URBAN DESIGN COMMISSION APPLICATION

Title: Heather Crest Streetscape

RE: Hilldale Shopping Center
Heather Crest Reconstruction
SIP Submittal

Summary of Proposed Changes: Adopted Plan

C 202

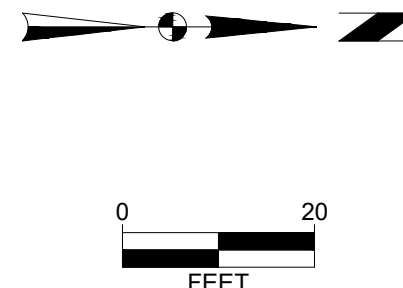
Relocating bike parking from Heather Crest Drive/Kelab Drive to an internal site location on the east side of Building 100.

Reduce vehicular travel lanes from 24 feet to 22 feet, overall the private street section remains as originally approved.

Remove three parallel parking stalls nearest the corner of Heather Crest Drive/Kelab Drive and Price Place.
